DR 07-04 – American Steel – An application requesting Site and Design Review for approval for a 190,585 sq ft building with a screened yard to the south to accommodate the operations of American Steel. The site is located on 10.34 acres immediately north of the Southern Pacific railroad, south of Township Road, east of the existing BBC facility, and west of the proposed Sequoia Parkway extension (Walnut Street) in Canby.

STAFF REPORT

VLMK Consulting Engineers
3933 SW Kelly Avenue
Portland, OR 97239
(representing American Steel, LLC)

BUILDING ELEVATIONS

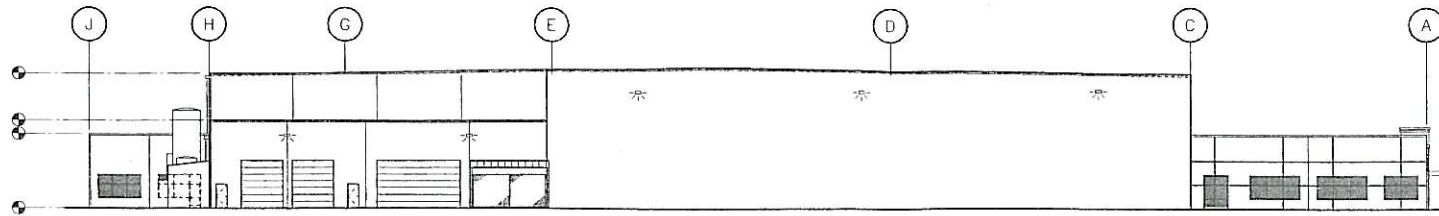
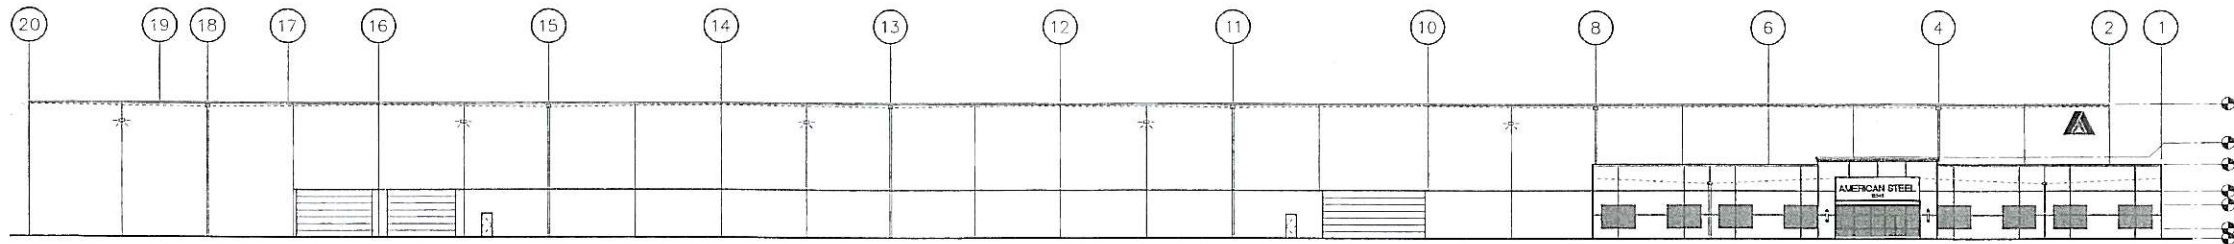
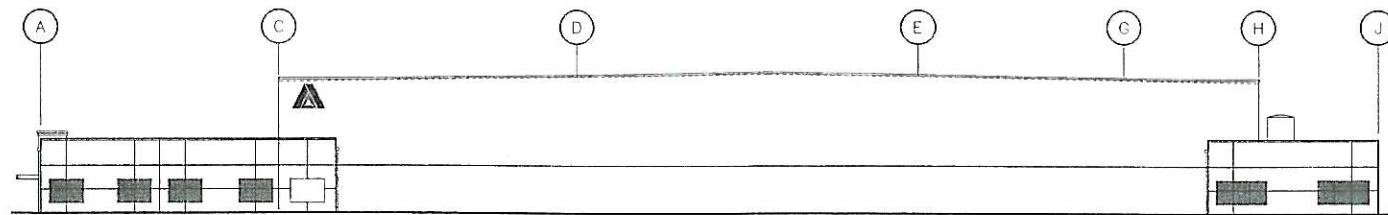
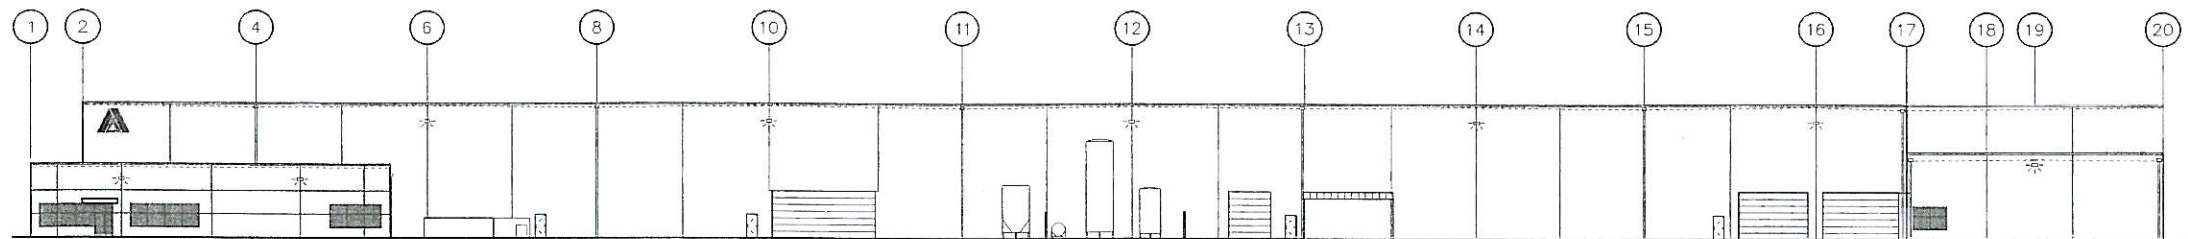
Building elevations are shown on the last two sheets of the applicant's packet. The last sheet provides an illustration of the proposed color scheme: basically, a very large beige expanse. The building has concrete tilt-up perimeter walls supporting a hybrid wood/steel roof. The main walls of the building are 40' high and the office areas have 24' walls. The office areas are called out with tinted storefront glazing, a darker shade of beige paint, and signage with blue accents. The main entry on Sequoia Parkway has a slightly raised cornice, an extra panel

for added depth, and a rounded metal canopy overhead. The proposal is compatible with surrounding development and with the Industrial Area Master Plan.
